### WATER POLLUTION CONTROL PERMIT NUMBER NEV88009

#### **Newmont Mining Corporation McCoy/CoveMine**

**NDEP Response to Tom Myers comments**  
**Letter received via e-mail on October 6, 2006**  
(NDEP Responses in **bold italics**)

Re: Water Pollution control Permit NEV88009 Renewal  
Newmont's McCoy/Cove Mine

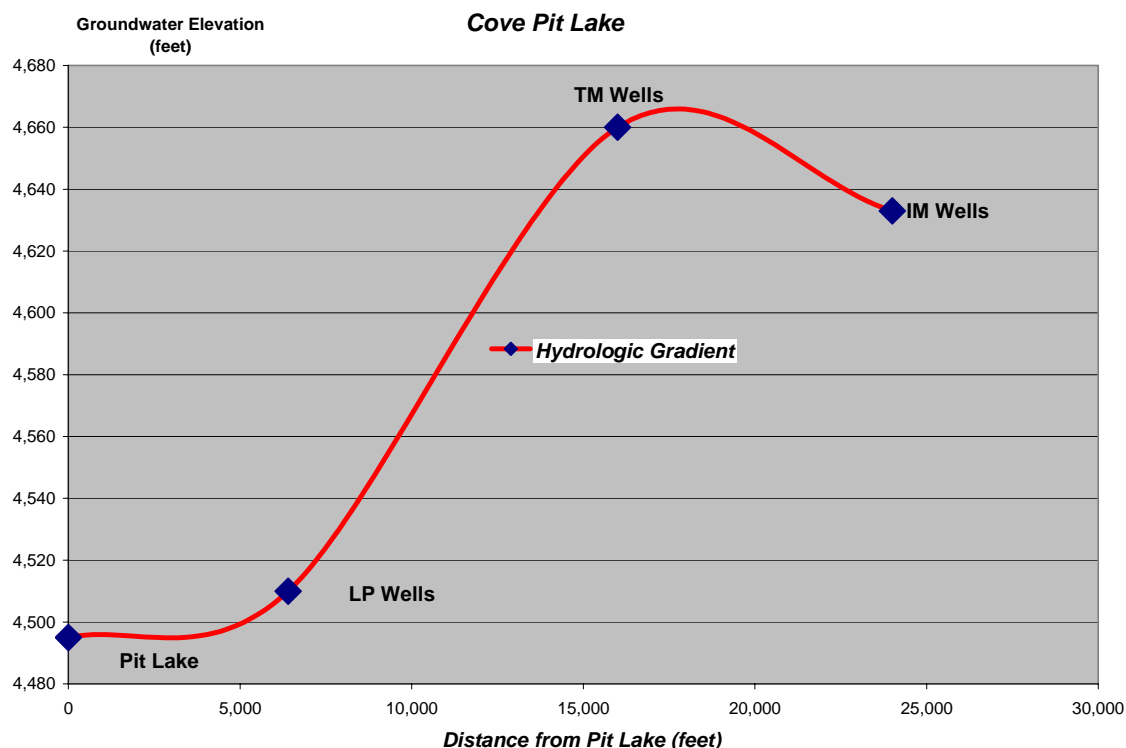
**(Comment 3)** Because there is insufficient monitoring of groundwater levels near the pit lake, it is not possible to determine groundwater contours and gradients near the pit. Without this type of monitoring, it is not possible to determine whether the pit lake is currently a throughflow system or not.

*NDEP Response: Comparison of pit lake levels and groundwater levels from site monitor wells, LP-2B, LP-5B, TM-3, 4 & 5 and IM-2 & 3, clearly show a steep gradient toward the pit lake. Groundwater at the leach pad wells is at an elevation of 4510 feet amsl, the tailings impoundment at 4660 feet amsl and 4633 feet amsl at the IM wells, whereas the pit lake level is currently 4495 feet amsl – indicating groundwater gradients ranging from 15 feet to 165 feet. See graph below. Current measurements indicate the pit lake is filling at approximately 2,000 gallons per minute.*

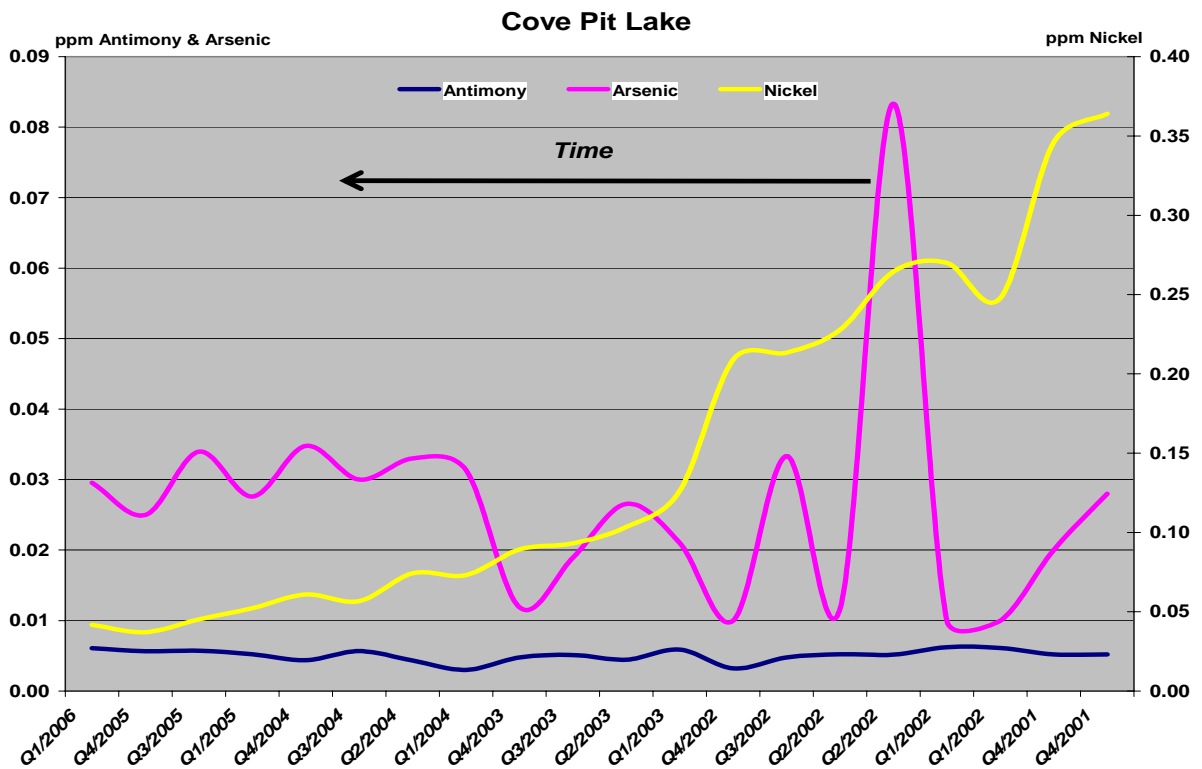
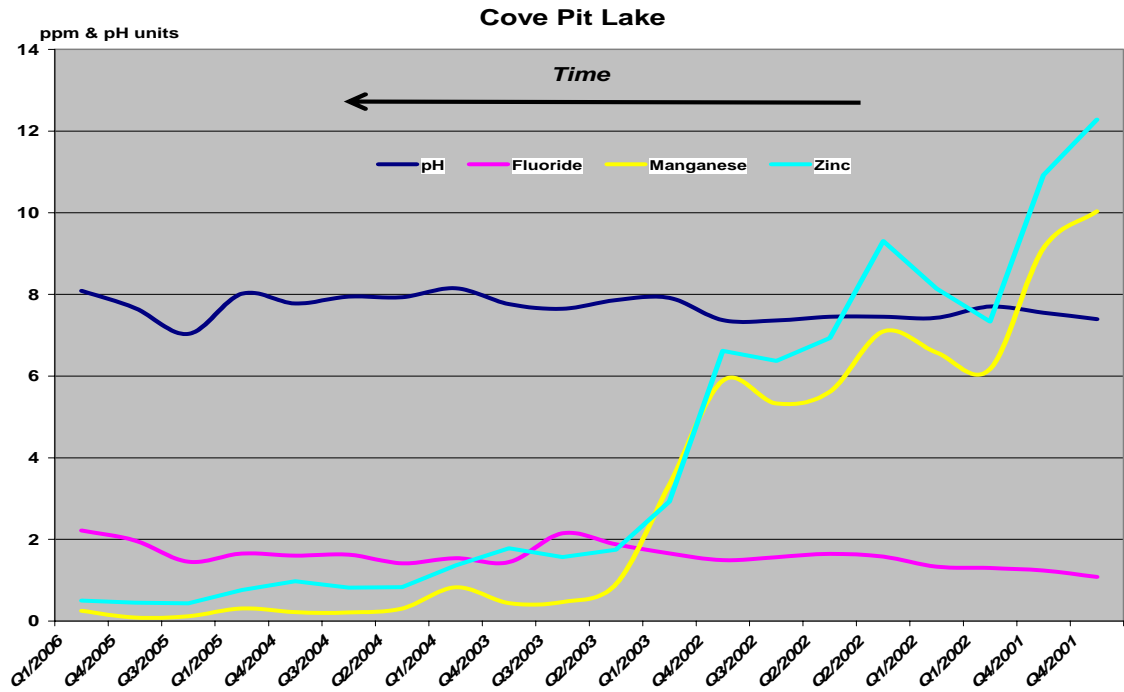
**(Comment 5)** The pit lake has filled much faster than expected as well because the inflows have been twice the predicted rate<sup>3</sup>. The inflow is likely from the bedrock on the uphill side of the pit. The inflow currently substantially exceeds the outflow which causes the pit lake level to rise. The lake level is likely higher than the groundwater level on the downhill side of the pit and is possibly in alluvium, which is probably not contributing inflow to the pit because any local recharge into the alluvium would likely follow the local topography and flow towards the Reese River. Because the pit lake has risen quicker than the groundwater would have likely recovered below the pit, it is likely there is currently flow through the pit. Because of the current lousy water quality<sup>4</sup>, it is probable that there is ongoing degradation.

*NDEP Response: The above mentioned Valley Fault hydrologic barrier, which precludes flow from the shallow alluvial aquifer, will also inhibit flow from the pit lake. The transmissivity through that section is approximately 0.0033 feet per day. The lake level will not reach the alluvium, but will be bound mostly by Smelser Pass limestone.*

*As shown graphically below, the water quality in the pit lake has demonstrated significant improvement over a very short life to-date and generally meets the Nevada Profile I reference values.*

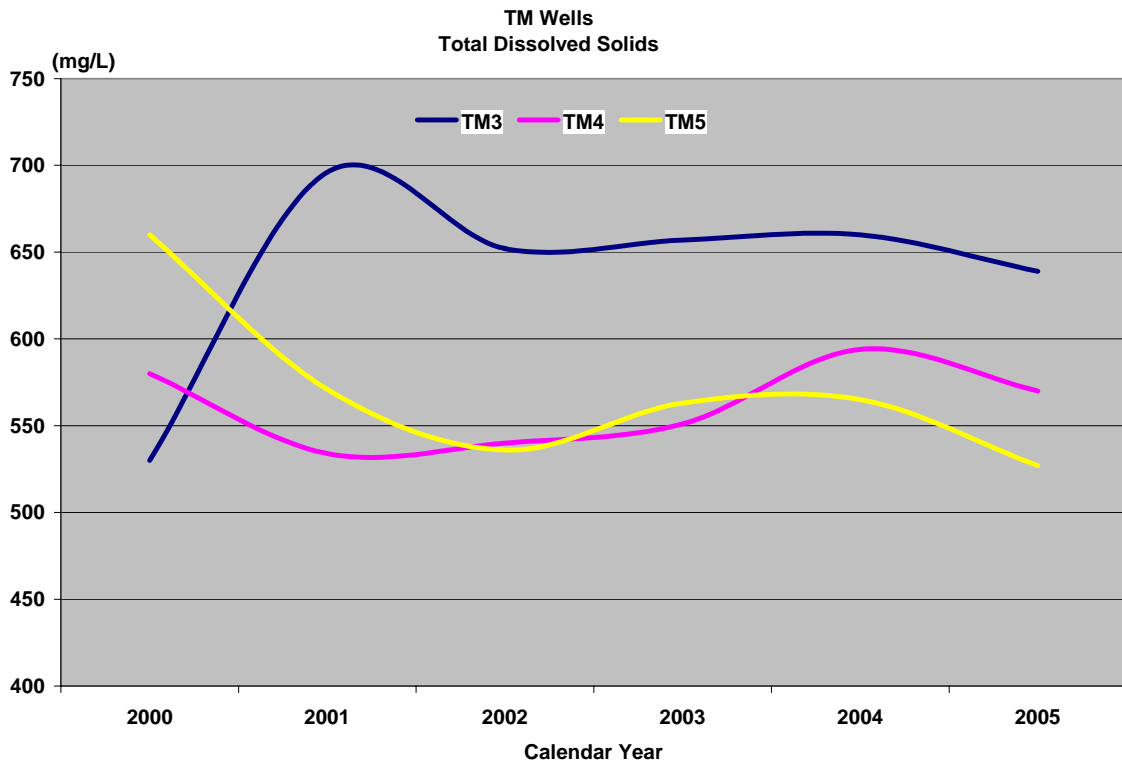
**(Comment 14)** The three tailings monitoring wells, TM-3, TM-4 and TM-5, are just downgradient of the tailings impoundment and provide a means to monitor the upper 30 feet of shallow groundwater. The location and screens of these wells appears to be adequate. However, there may be some exceedences or increasing trends in parameter concentrations that NDEP should consider (even if they do not yet represent standard exceedences, they indicate an upward trend may be occurring.) Based on the 2003 annual report (the most recent one found in the files), at TM3, TDS appears to be increasing. At TM4 aluminum has exceedences for four years and iron does for three of four years.

*NDEP Response: Provided below is a graph of TDS for the TM wells for the last six years which show decreasing trends.*
